AMENDMENTS TO THE DRAWINGS:

REMARKS

Appl. No. 10/826,272
Amendment dated April 17, 2008
Reply to Office Action of November 15, 2007

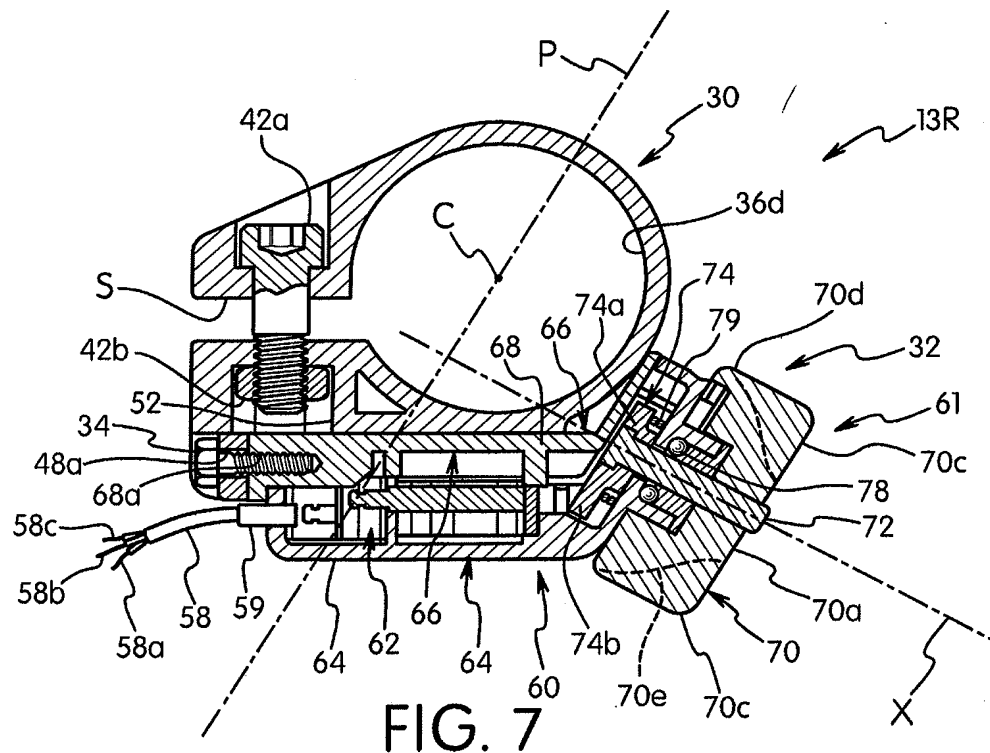
In paragraph 4(a) of the Office Action, the drawings were objected to for allegedly introducing new matter in Figure 7. This objection is respectfully traversed as set forth in the January 15, 2008 Petition under 37 CFR §1.181. Specifically, in the August 2, 2007 Amendment, Applicant added the plane P that is perpendicular to the rotation axis X and passes through the center axis C to Figure 7. Also, the reference character "S" identifying the split was added to Figure 7. See the reproduction of Figure 7 from the August 2, 2007 Amendment below.

In paragraph 4(b) of the Office Action, the Office Action indicates that the changes to the drawings by the August 2, 2007 Amendment were not sufficiently explained. Thus, the changes are now explained. Applicant added the plane P that is perpendicular to the rotation

axis X and passes through the center axis C to Figure 7. Also, the reference character "S" identifying the split was added to Figure 7.

Adding this plane P that is perpendicular to the rotation axis X and passes through the center axis C to Figure 7 does not constitute an introduction of new matter. Rather, such a plane was inherently present in original Figure 7, but was merely not yet explicitly identified. In other words, a plane that is perpendicular to the rotation axis X and passes through the center axis C is inherently present in original Figure 7, and thus, is merely being clearly, explicitly identified as plane "P" by the August 2, 2007 Amendment. This change to Figure 7 was made in view of the changes to claim 22 (i.e., the plane and split are set forth in amended claim 22) and in view of an objection in the April 18, 2007 Office Action that "a mating mounting structure" set forth in the claims was not identified with a reference numeral. In other words, based on this prior objection, Applicant believed that the plane P and the split S should be clearly identified in the drawings to avoid a potential objection. In other words, Applicant believes that new identifying information was added to Figure 7, not

Fig. 7

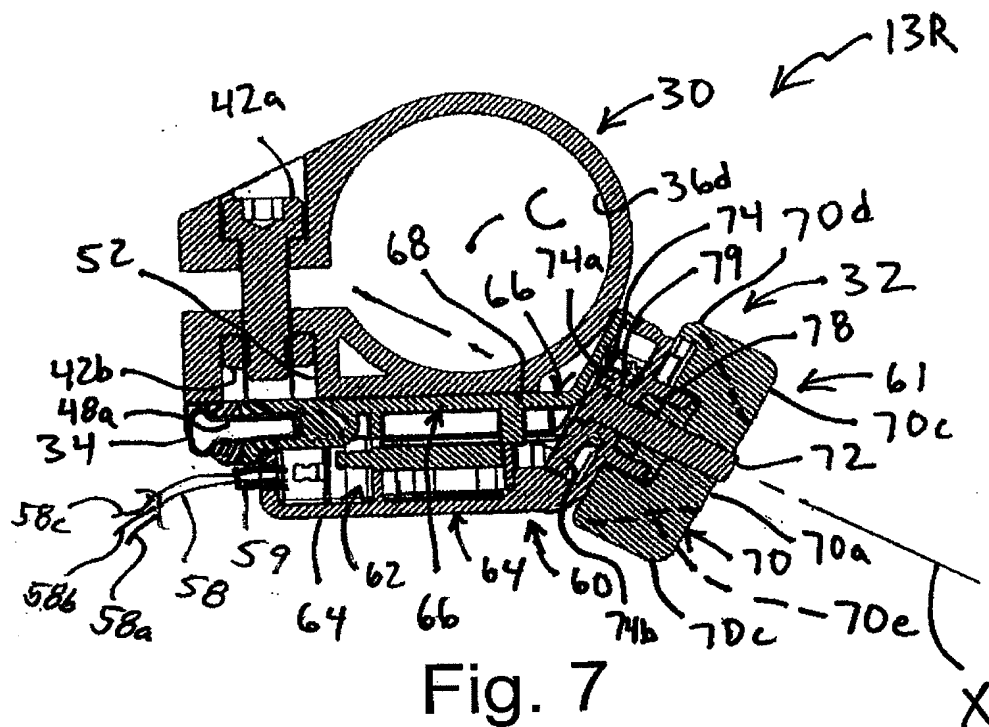
In paragraph 6 of the Office Action, August 2, 2007 Amendment was objected to for allegedly introducing new matter in paragraph [0064]. This objection is respectfully traversed as set forth in the January 15, 2008 Petition under 37 CFR §1.181. Specifically, Applicant amended paragraph [0064] to state "The pivot axis X preferably intersects the curved mounting surface 36d of the tubular clamping portion 36 such that the operating member 61 is disposed on an opposite side of a plane P from the split S. The plane P is perpendicular to the operating axis X and passes through the center axis C of the transverse portion T of the handlebar 14, as best seen in Figure 7." Adding this language to the specification does not constitute an introduction of new matter. Specifically, such language is clearly supported by the original drawings (e.g., original Figures 3-6) and the original specification, which form parts of the original disclosure. See original Figure 7, which is reproduced below.

It is clear from this Figure that *the operating member 61 is disposed on an opposite side of a plane (the plane being perpendicular to the operating axis X and passing through the center axis C of the transverse portion T of the handlebar 14) from the split of the portion 30*. In fact, it is clear from this Figure alone that the operating member and the split lie on opposite sides of many different planes, the plane P merely being one that is easily identifiable because of its arrangement relative to the operating axis X and the center axis C of the transverse portion T of the handlebar 14. Based on the above comments, Applicant respectfully requests that this objection be withdrawn.
